# Newmar Corporation Warranty Department

## Technical Service Bulletin

Date Issued	Model Year(s) Affected	TSB #
9/1/2015	2015, 2016	TSB 427 Recall # 15v-492

# Recall Service Bulletin

**FIG. 2-1**

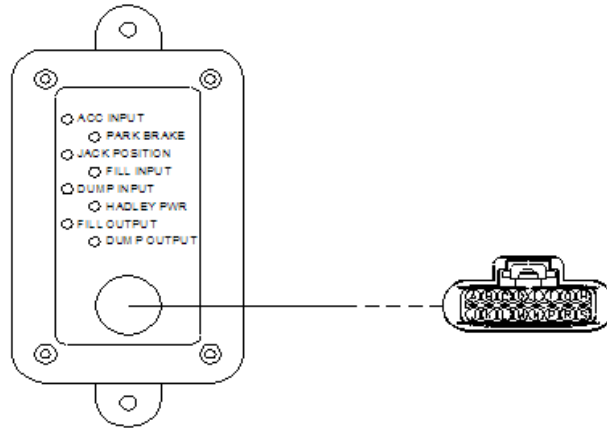
1. Locate Hadley Interface Module in the left front exterior compartment. Refer to FIG. 2-1.

2. Follow harness down and locate connector, approximately 12 inches from module.
3. Slide gray connector lock back, push down on latch, and pull connectors apart.
4. Remove screws securing the Hadley Interface Module to compartment wall and properly dispose of it.
5. Attach 0121-GG3-034 timer relay to the 3900-GG5-002 Hadley relay harness if not already attached (if the harness has single Faston terminals, plug terminals onto the corresponding number as shown on the tag). Refer to FIG. 2-2.
